Re: Capital Commerce Center – Lunenburg Road – Lancaster, Massachusetts  
Response to Traffic Engineering Peer Review

**Vanasse and Associates, Inc. (Jeffrey S. Dirk, PE, PTOE, FITE) – September 7, 2021**

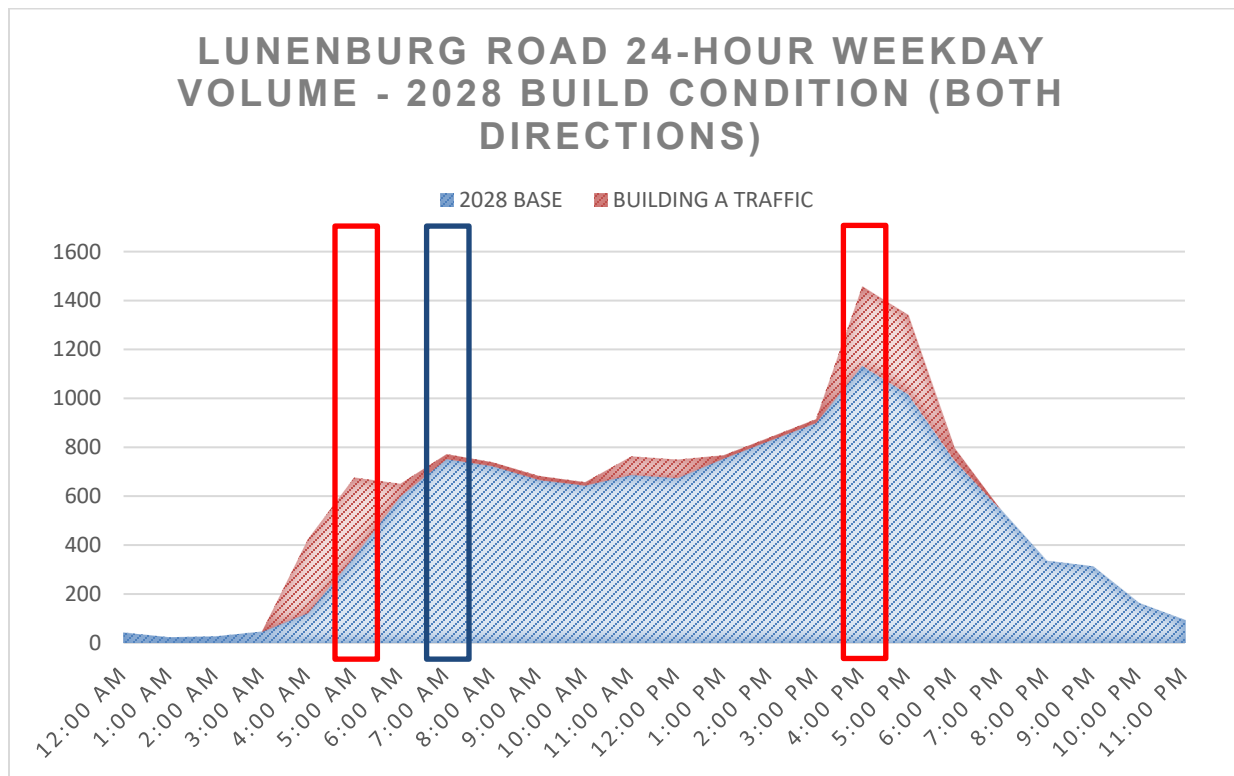
- T2. Additional information is required to substantiate the trip-generation calculations for Building A. The type of warehouse should be identified (i.e., non-sortation or sortation fulfillment center, or other) and a traffic flow profile for an average weekday and Saturday should be provided that superimposes the 24-hour traffic flow profile of Building A onto the traffic volumes along Lunenburg Road. This composite traffic flow profile should identify traffic volumes during the peak-hour of the roadway, the**

**peak-hour of the generator (Building A) and the traffic volumes during the design hours that were assessed in the July 2021 TIAS.**

TEC Response: The tenant's name has not been released; however, the land use can be described as a box-store distribution center. The trip generation information provided for Building A is empirical data supplied by the proposed tenant for the specific facility, which is based upon equivalent facilities current in place, including the entering and exiting traffic for both employees and trucks.

The exhibit below is a weekday hour-by-hour chart comparing Building A site generated traffic and the existing traffic volumes along Lunenburg Road, north of McGovern Boulevard (64% of use traffic). The chart shows an overlap of the peak site generator traffic and commuter traffic during the weekday evening peak period and a separation of the peak commuter traffic and the peak site generator traffic during the weekday morning period. The TIAS traffic operational analysis is completed to show an overlap of the peak commuter and peak site generator traffic to provide a conservative scenario.
